Serial: NPD-NRC-2009-101
June 10, 2009

**LEVY NUCLEAR POWER PLANT, UNITS 1 AND 2
DOCKET NOS. 52-029 AND 52-030
RESPONSE TO REQUEST FOR ADDITIONAL INFORMATION LETTER NO. 028 RELATED TO
EMERGENCY PLANNING – EVACUATION TIME ESTIMATE**

**Levy Nuclear Power Plant Units 1 and 2
Response to NRC Request for Additional Information Letter No. 028 Related to
SRP Section 13.3 for the Combined License Application, dated May 8, 2009**

Figure 7-6. Congestion Patterns at 2 Hours, 30 Minutes After the Advisory to Evacuate (Scenario 8)

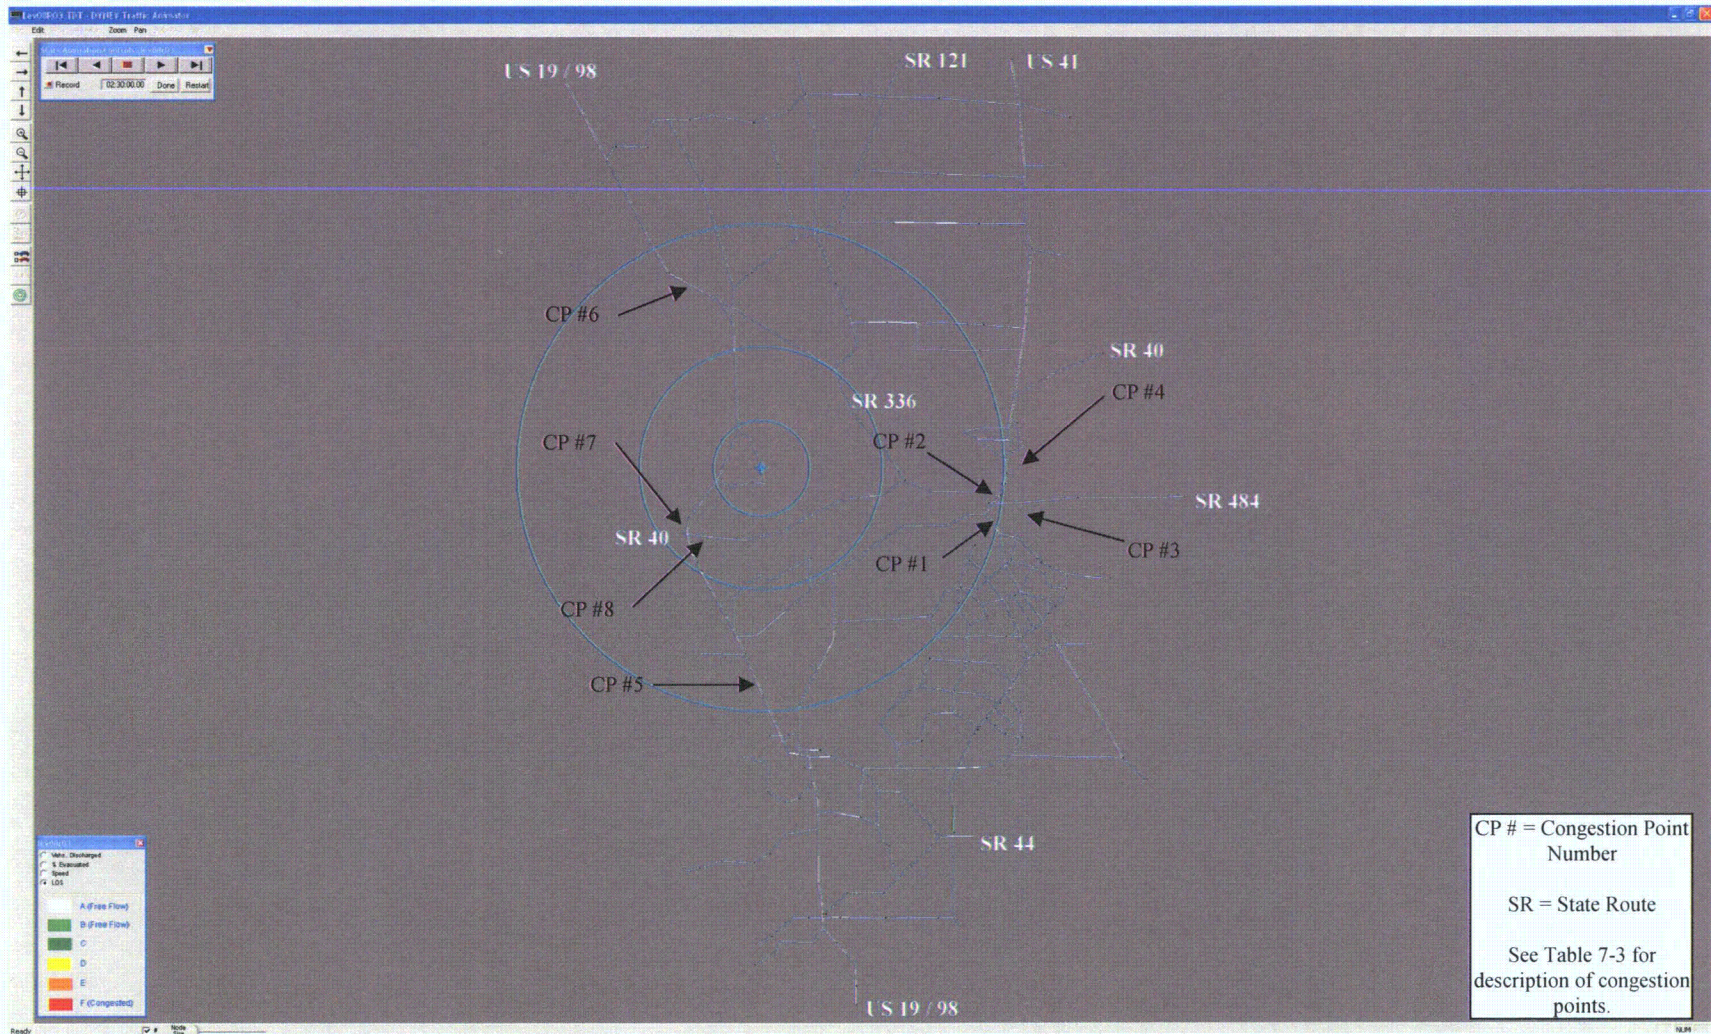
- B.** Section 2.1, "Data Estimates", (Page 2-1) assumption #7 states that the ETEs are presented for the evacuation of the 100th percentile. The evacuation times provided in Section 7, "General Population Evacuation Time Estimates (ETE)," indicate ETEs of about 5 hours for the general population, whereas the telephone survey results in Figure F-11, "Time to Prepare Home for Evacuation," (page F-10) indicate that it may take as long as 6 hours for the general public to prepare to evacuate. Clarify the inconsistency in the time it takes to evacuate 100 percent of the general population.

As discussed on Page 7-2 and displayed in Figure 7-6, the congestion clears from the EPZ well before the trip generation time of 5 hours; thus the ETE for the 100th percentile is dictated by the trip generation time. The congestion within the EPZ has dissipated by 2 hours and 30 minutes after the advisory to evacuate. This discussion references the evacuation of the entire EPZ (Region R03) under Scenario 8 conditions. Consequently...
